Comment Letter I38

## Response to Comment Letter I38

**Donna Tisdale for the Boulevard Planning Group (as an individual)**  
**March 2, 2014**

**Soitec Solar partial and incomplete list of errors, omissions** (ran out of time for full review or proper organization and editing)

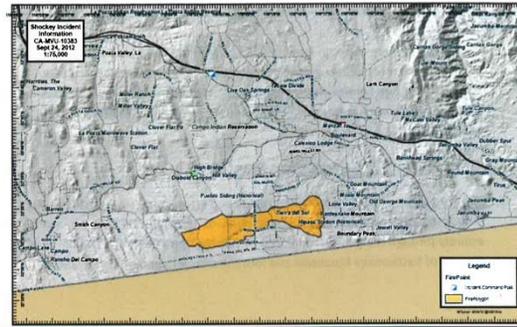
7. @ page 3.1.5-11: *Topography, Hydrology, and Drainage Patterns LanEast site*: this section states that Walker Creek passes through the site before entering the 514 acre Walker Canyon but fails to disclose the adjacent Walker Canyon Ecological Preserve that “provides seasonal water and riparian habitat along its drainage<sup>8</sup> and then drains into Carrizo Creek in Anza Borrego Desert State Park . Dr VM Ponce’s report on the Soitec Solar projects includes a side by side figure showing the proximity of the LanEast site and the Walker Canyon Ecological Reserve (Figure 49)<sup>9</sup>.”

|  | <p>Patterns LanEast site. The County has revised DPEIR pg. 3.1.5-12 to state that the LanEast site is adjacent to the Walker Canyon Ecological Reserve.</p> <p><b>I38-54</b> The County acknowledges the commenter’s concerns regarding the Emergency Service Capabilities Assessment. , CalFire data was utilized within a Geographic Information System to determine which of the recorded fires in the area had burned onto the Tierra del Sol site. This bullet point list provides only information pertaining to those fires and is not meant to provide a complete summary of all wildfire statistics, including but not limited to total size, and structures lost. A full description of the Shockey Fire occurs on page 28 of the Emergency Services Capabilities Assessment. No further information or exhibits are required as they do not alter the analysis or conclusions.</p> <p><b>I38-55</b> The County acknowledges the commenter’s concerns regarding the conclusions of the Emergency and Service Capabilities Assessment. An Emergency Service Capabilities Assessment and Cumulative Impact Mitigation study (Appendix 3.1.7-1) was prepared specifically for the Proposed Project and evaluates the potential impacts to fire and emergency medical response capabilities during construction, decommissioning, and operation of the Proposed Project sites. It objectively evaluates those potential impacts, and conservatively evaluates those impacts in light of</p> |
